| Project Title: | Fountain Wind Project |
| Document Title: | fwp_project_description_2024_update_redline |

Reference: Fountain Wind Project Updated Project Description

Project Description

Figure 2. Project Site Aerial

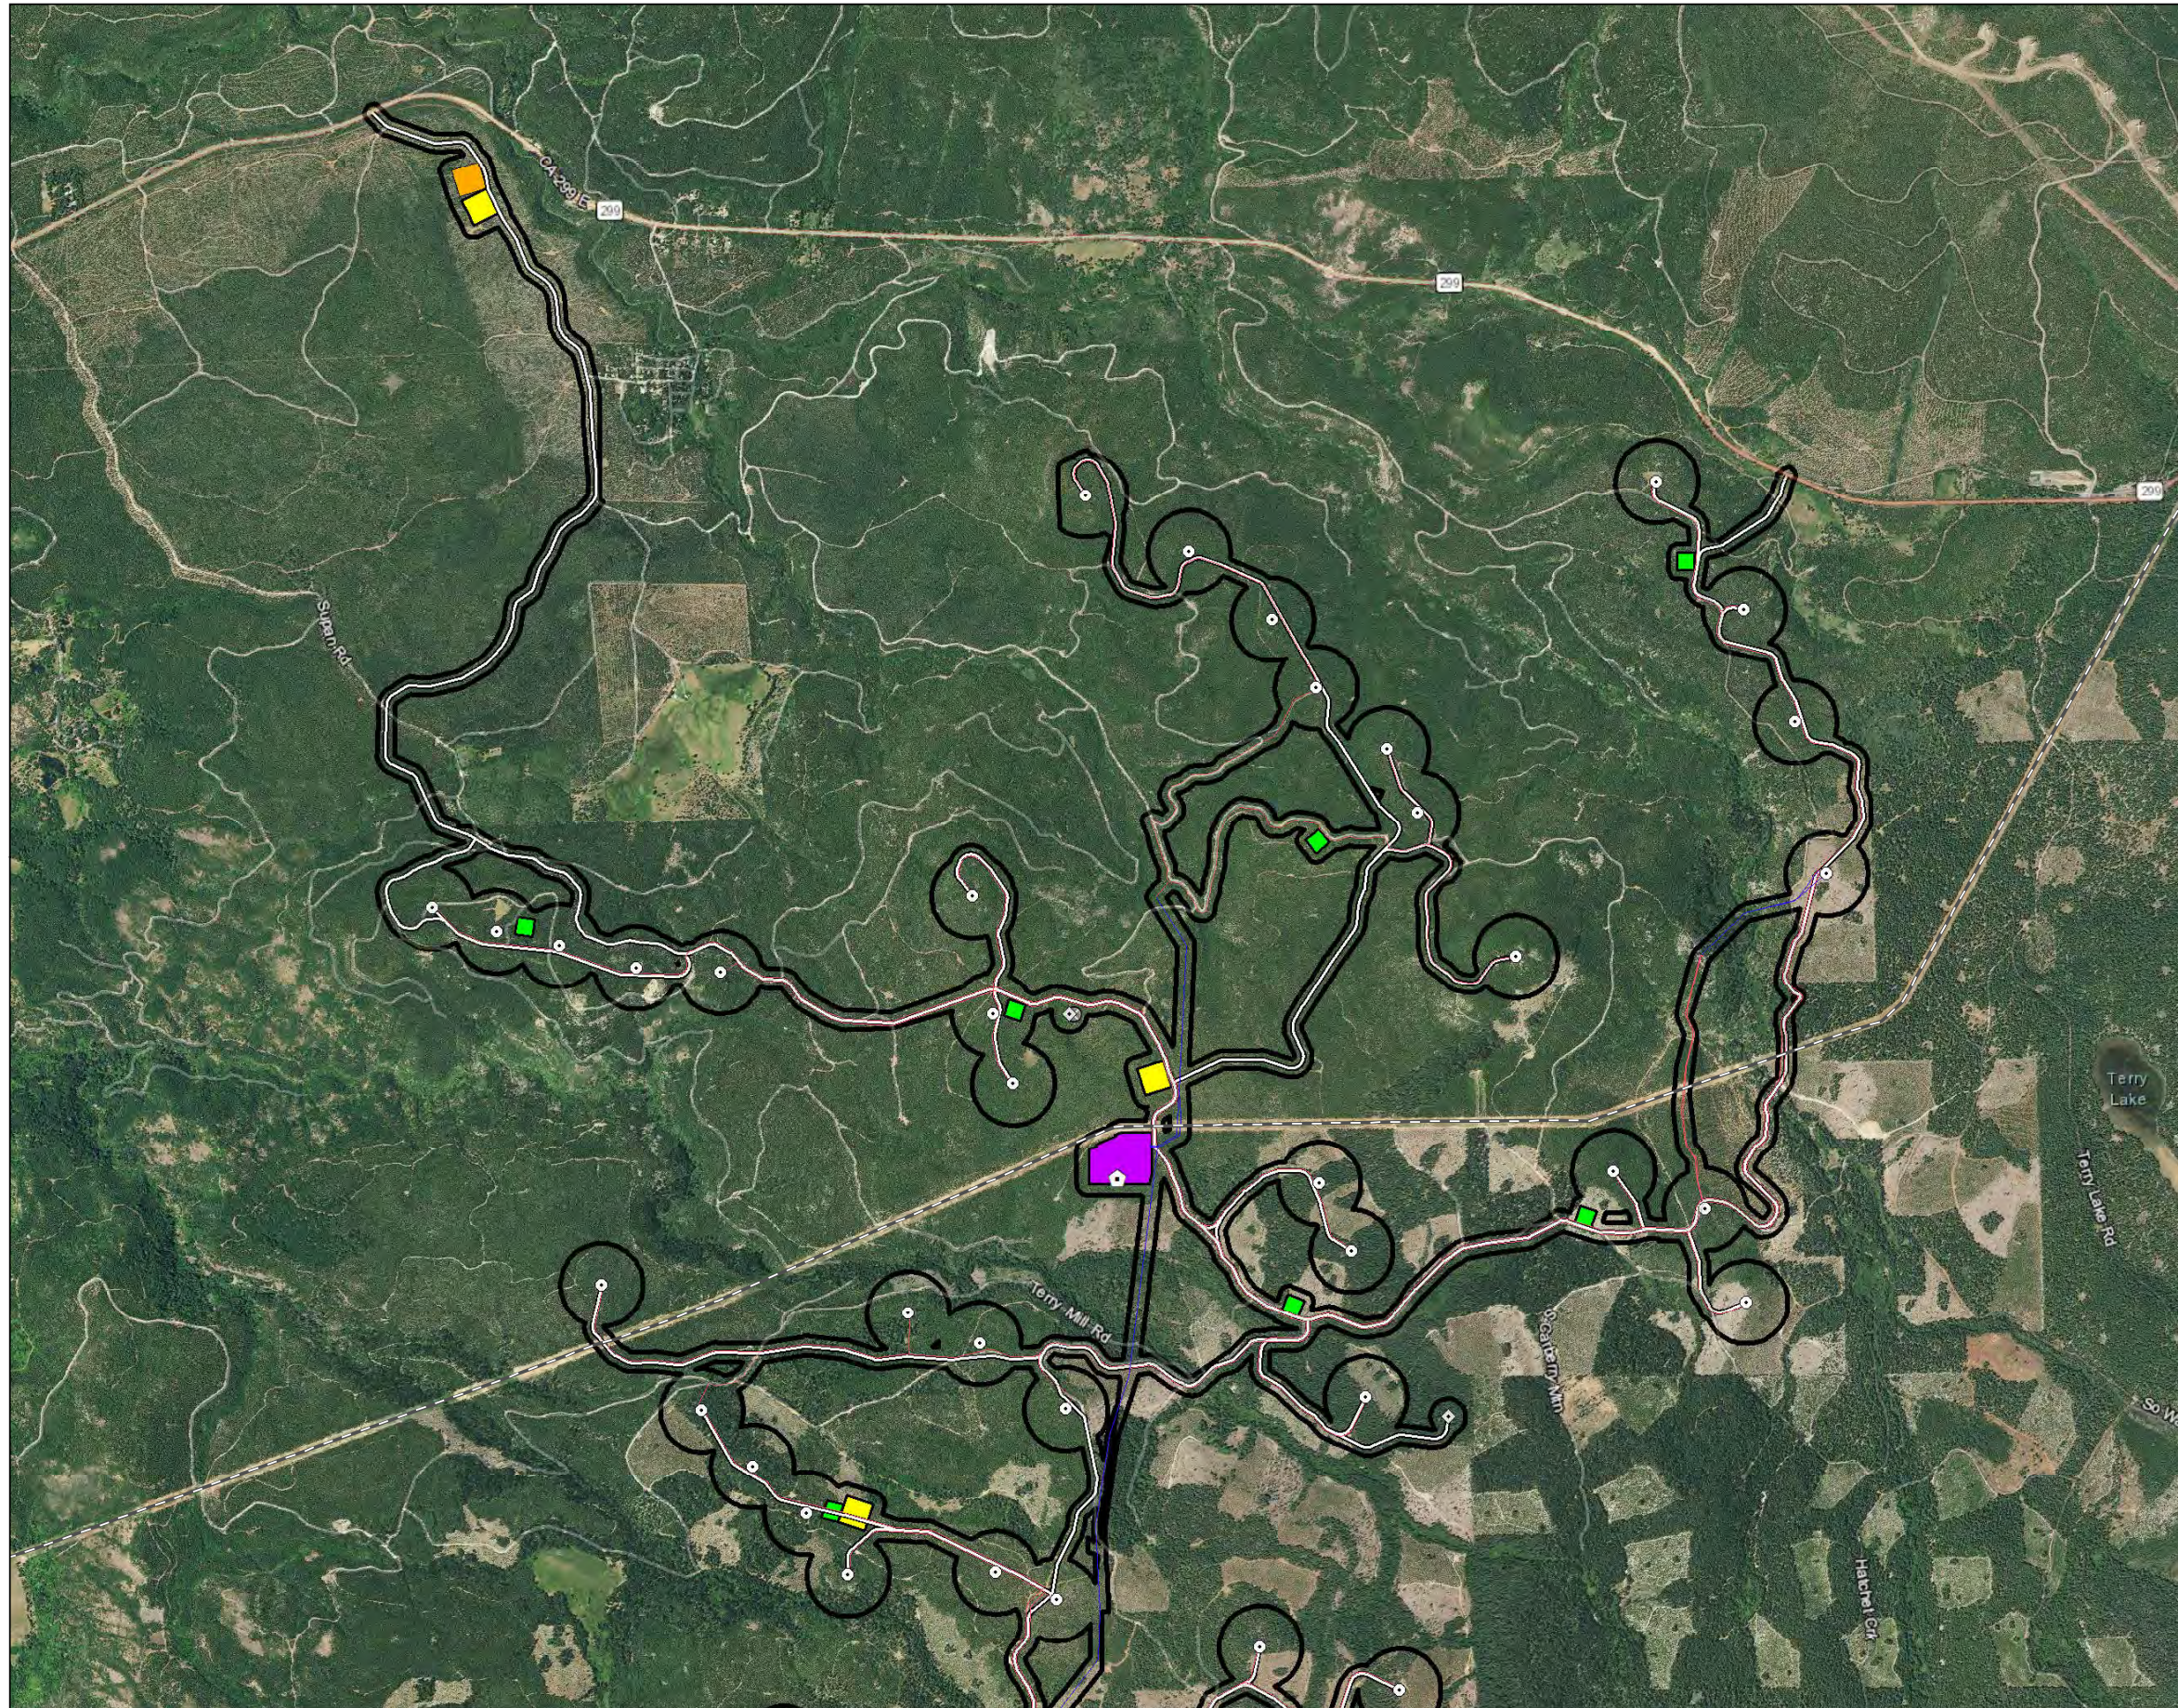
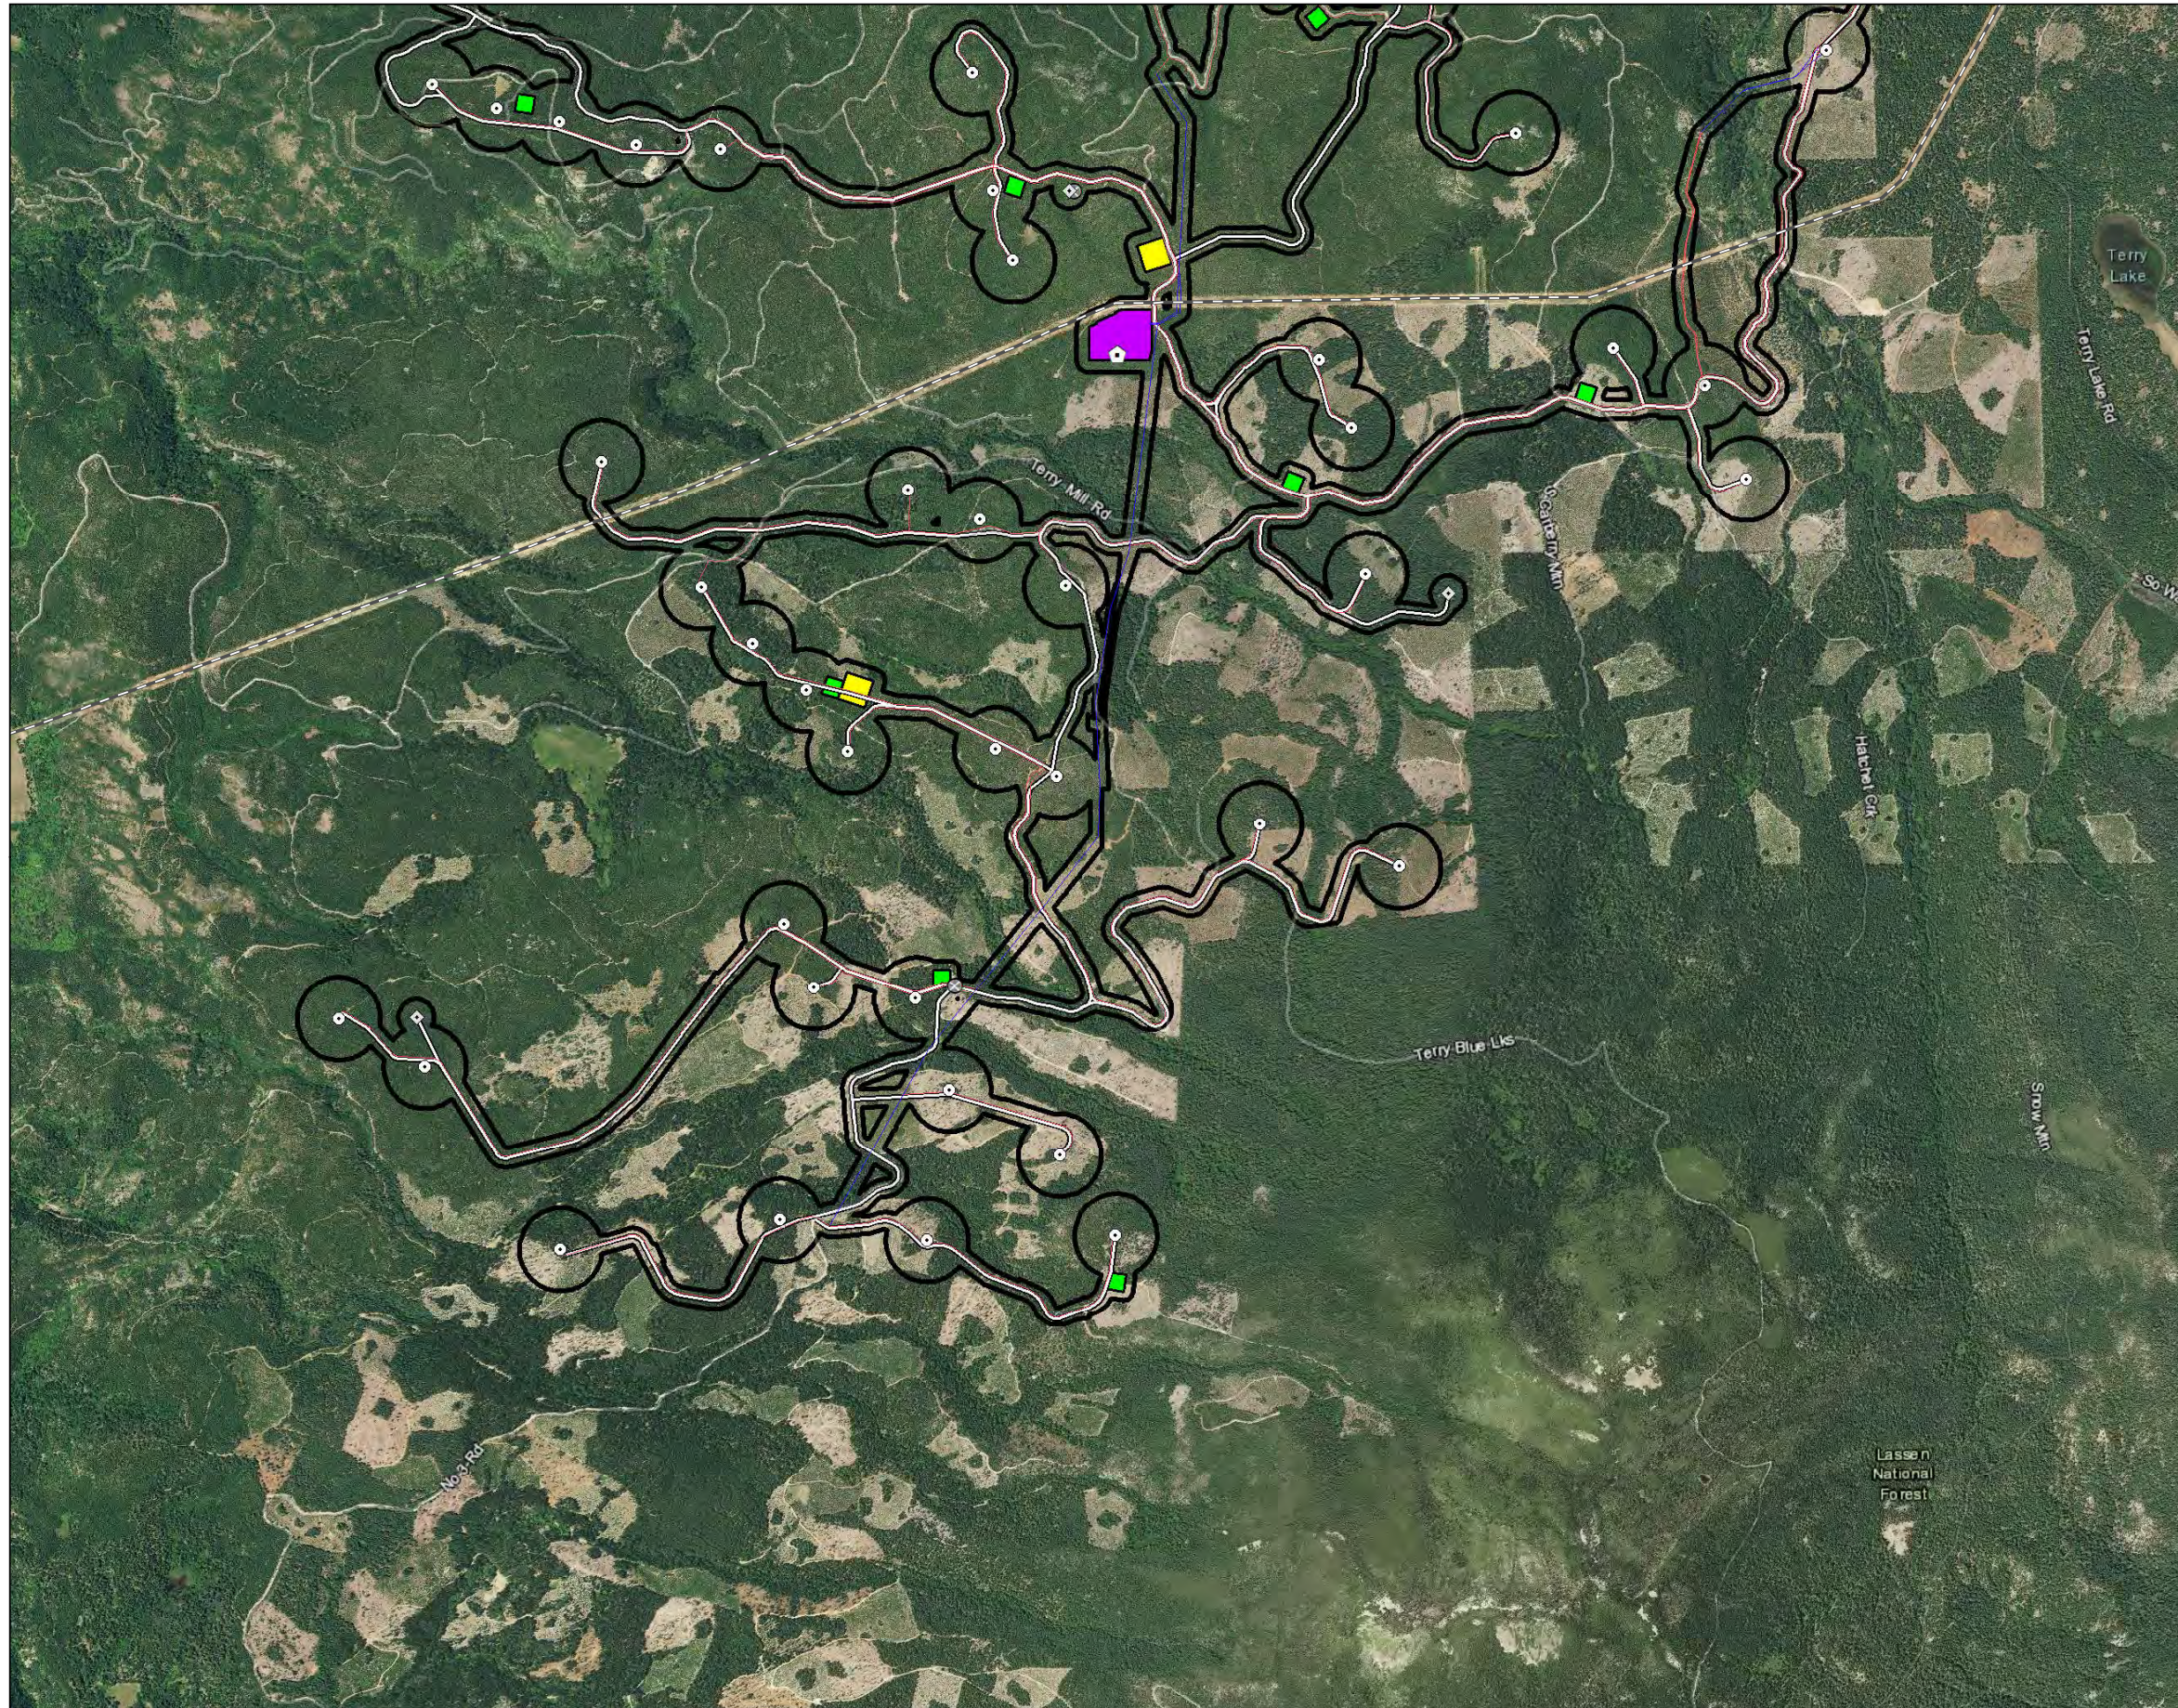
Figure 2 depicts 48 turbine sites that are being considered as part of the project. Final design may include fewer than 48 turbine sites. The 48 turbine sites represent feasible locations for a range of turbine models, each with different dimensions, generating capacity, and layout requirements. Prior to construction, the Applicant would determine which model would be installed based on component availability from the manufacturer, data on on-site wind resources, and other project-specific factors. Regardless of the model ultimately selected, the project would not exceed the proposed maximum 205 MW nameplate generating capacity and total tip height of each turbine would not exceed approximately 610 feet above ground level.

Up to three (3) permanent METs would be constructed within the project site to measure and record meteorological data to assess the performance of turbines and guide project operation (Figure 2). These METs would be un-guyed and freestanding to minimize impacts on avian species, would be up to 394 feet tall, and would comply with FAA lighting regulations. The Applicant would develop an FAA-approved lighting plan that is expected to specify the installation of flashing red lights on designated METs to improve visibility.
